CONVAIR
A Division of General Dynamics Corporation
San Diego, California

COMMERCIAL CHANGE PROPOSAL

SPNO NO: ZD-22-003 DATE: _____
CUSTOMER: Delta Air Lines Inc. MCL 10,158 Dtd _____
CHANGE NO: 100 MODEL: (880) 22-2

TITLE: **Tinted Interior Cabin Windows, Installation of**

Enclosure to CCP No. 99A

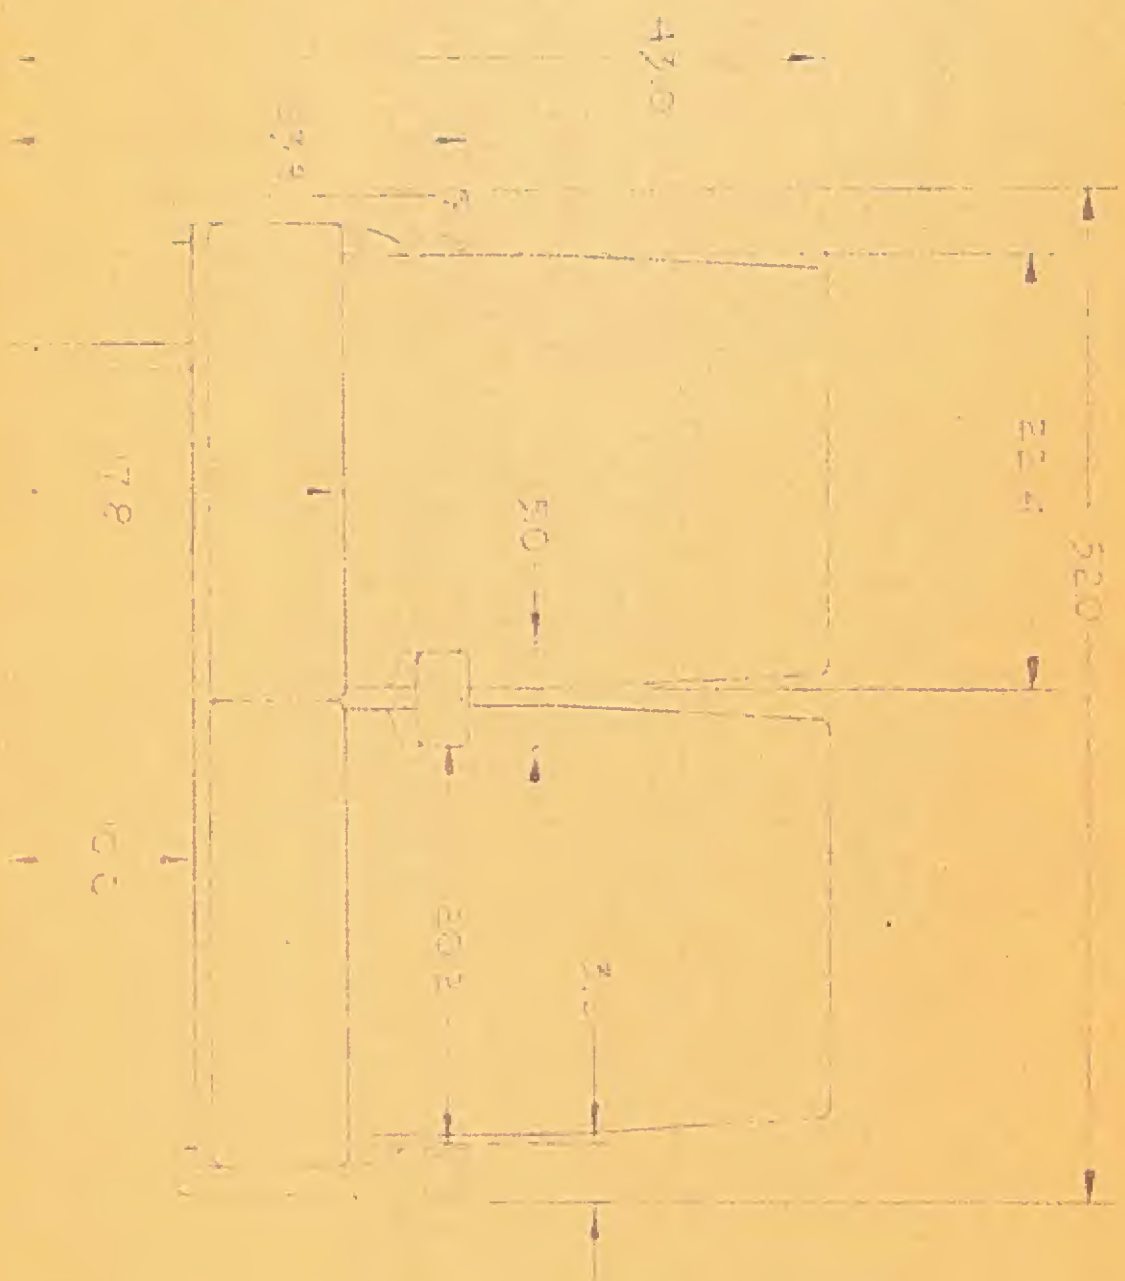
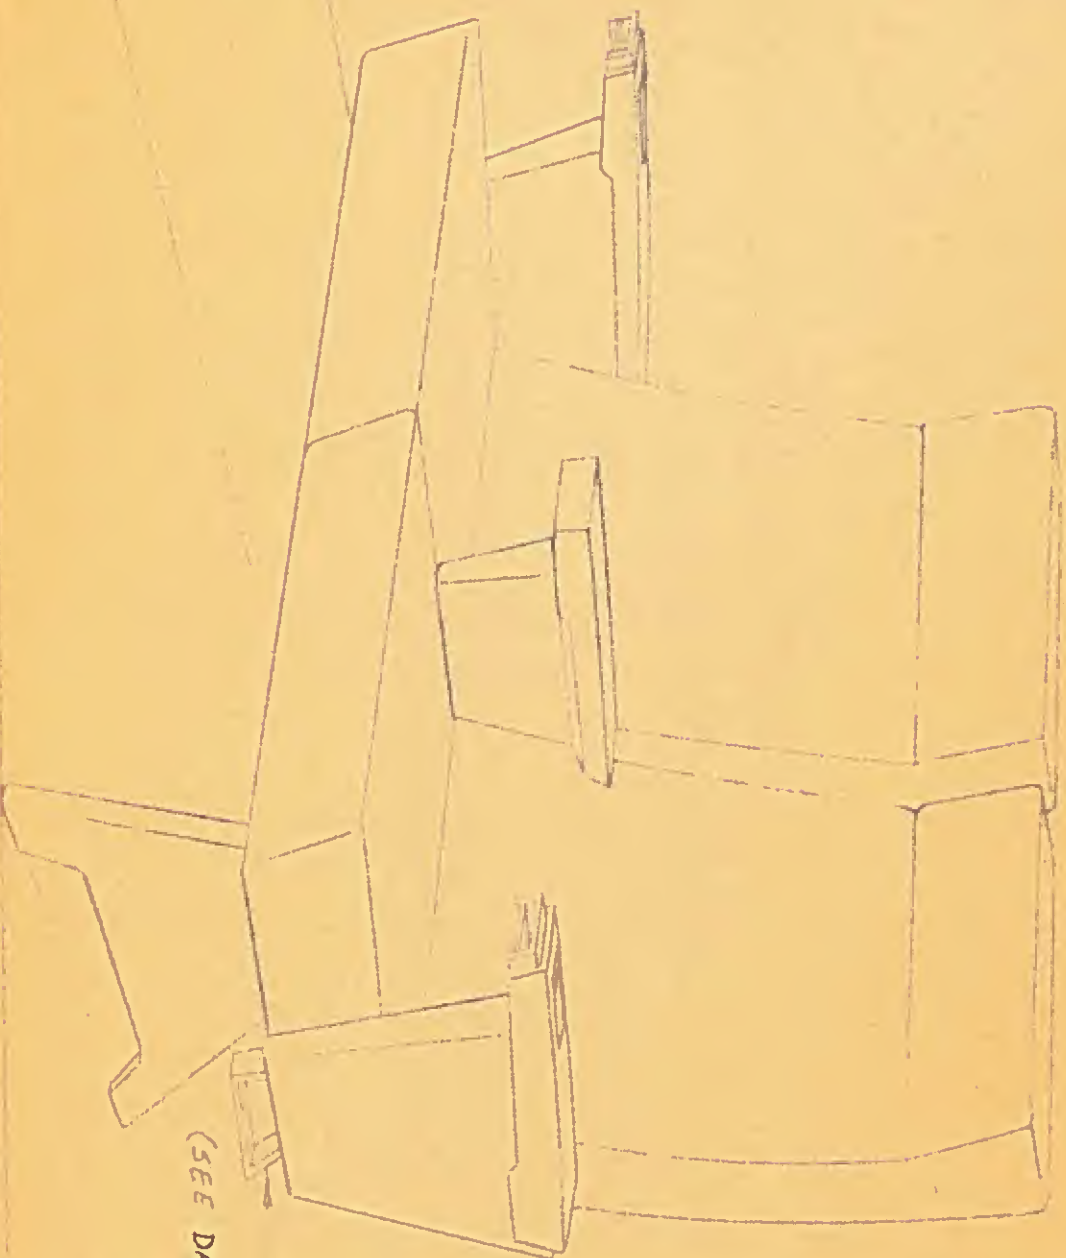
Reason for Change: To provide a seat in accordance with Customer comments.

Figure 1-2, INBOARD PROFILE AND PLAN VIEW:

Revise figure to show the following seat width and spacing:

ANTENNA ARRANGEMENT
Figure 3.17-3
(For Antenna location only)

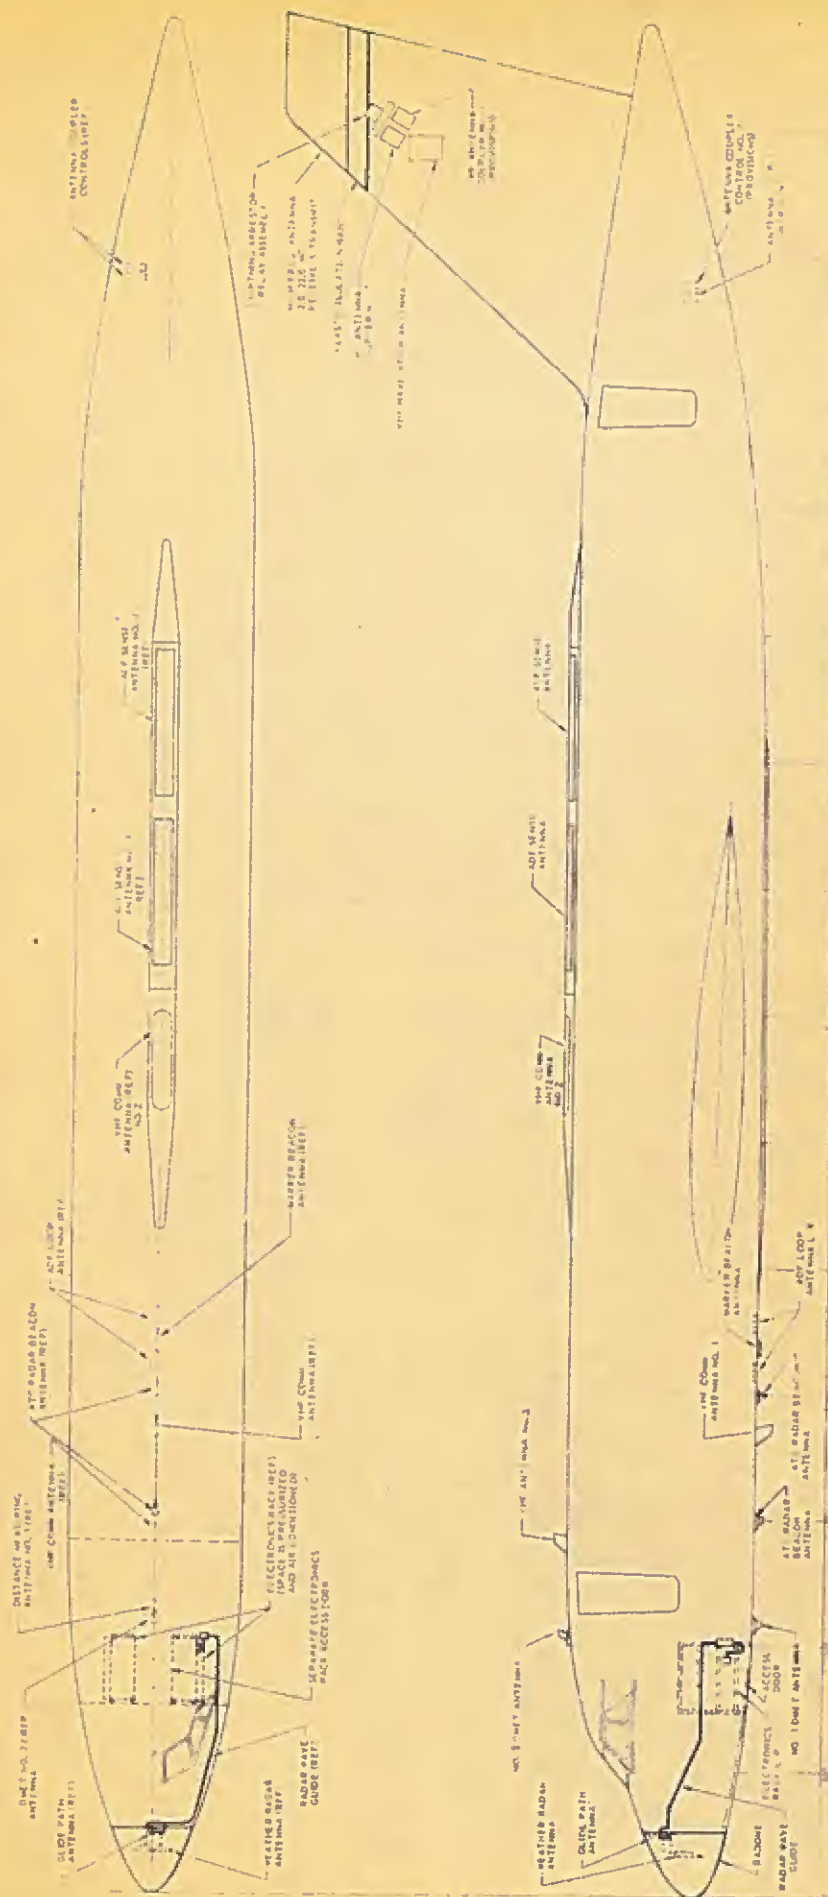
Change under VHF Communication Antenna:

Figure 3.17-3 RADIO GENERAL ARRANGEMENT

Delete: The above present Figure 3-17-3 and replace with Enclosure (A).

Enclosure: (A) One (1) copy Page 102C, Antenna Arrangement Illustration

FIGURE 3.19-4

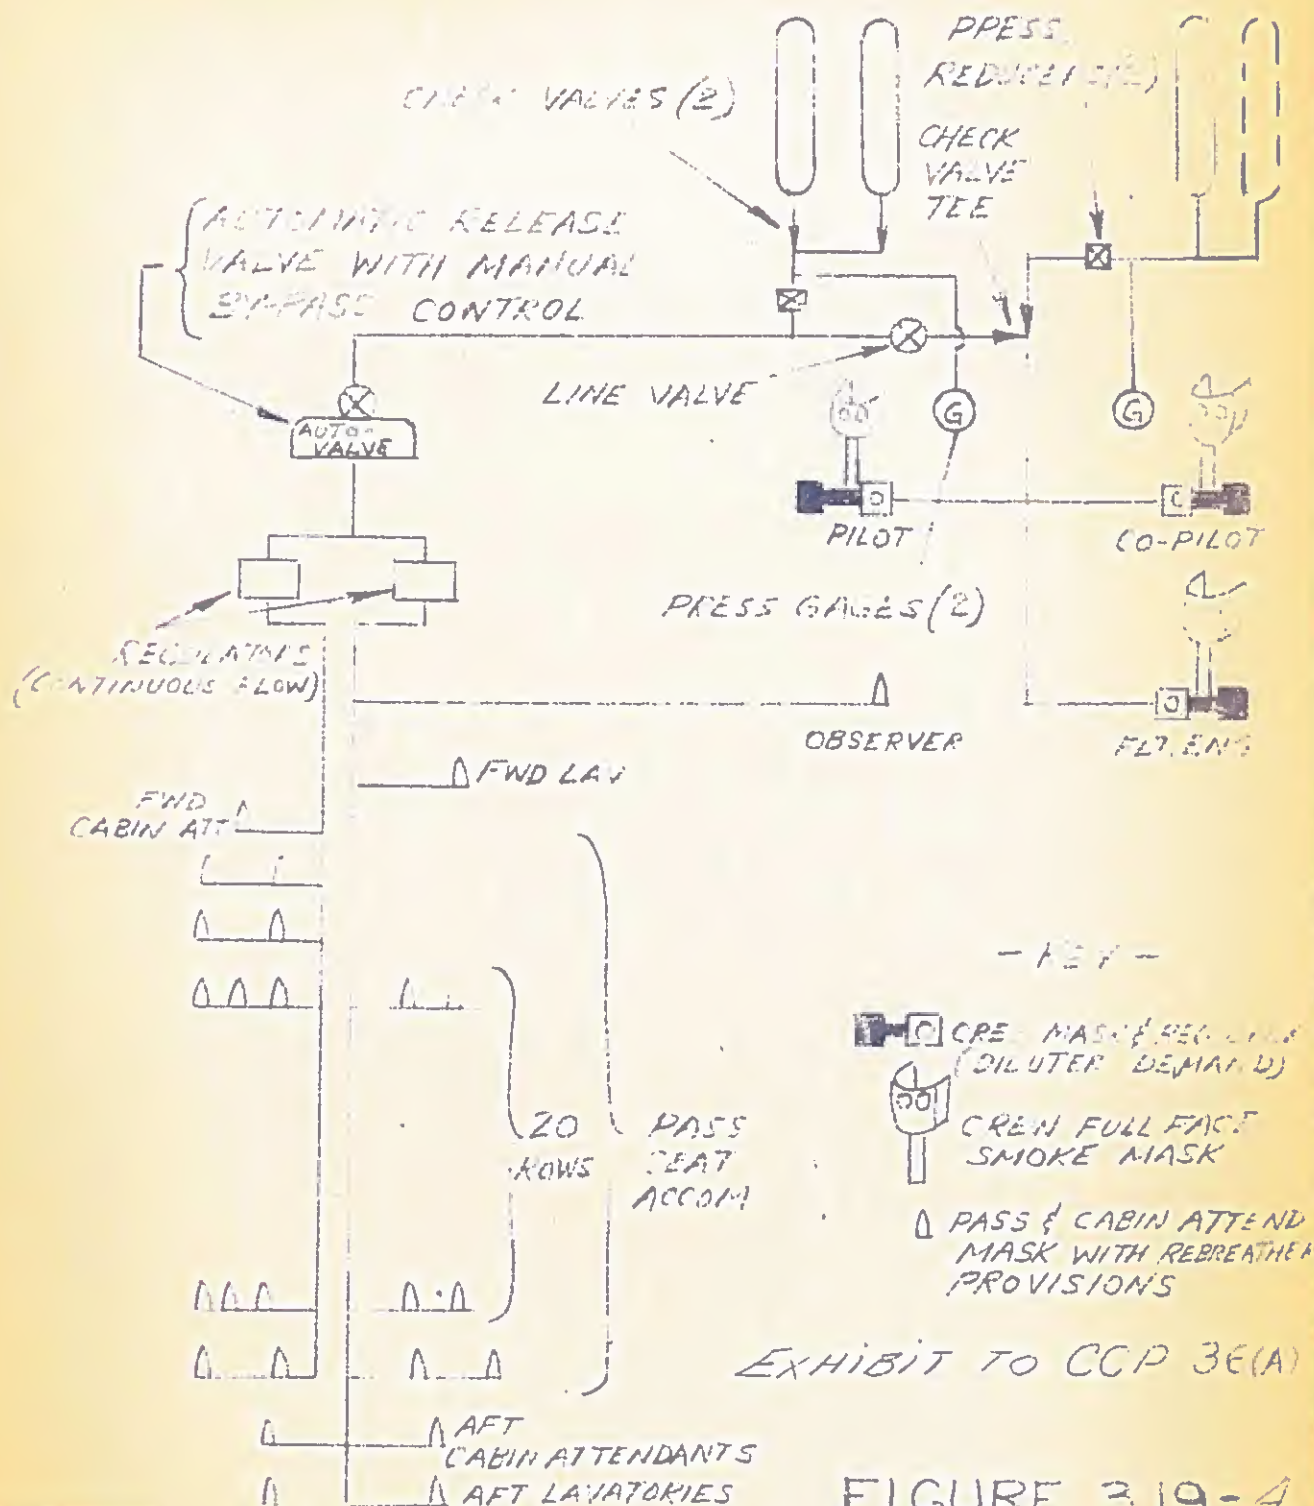
Add:

Figure 3.19-4 dtd 7-26-56

FIG 3.19-4 REVISED
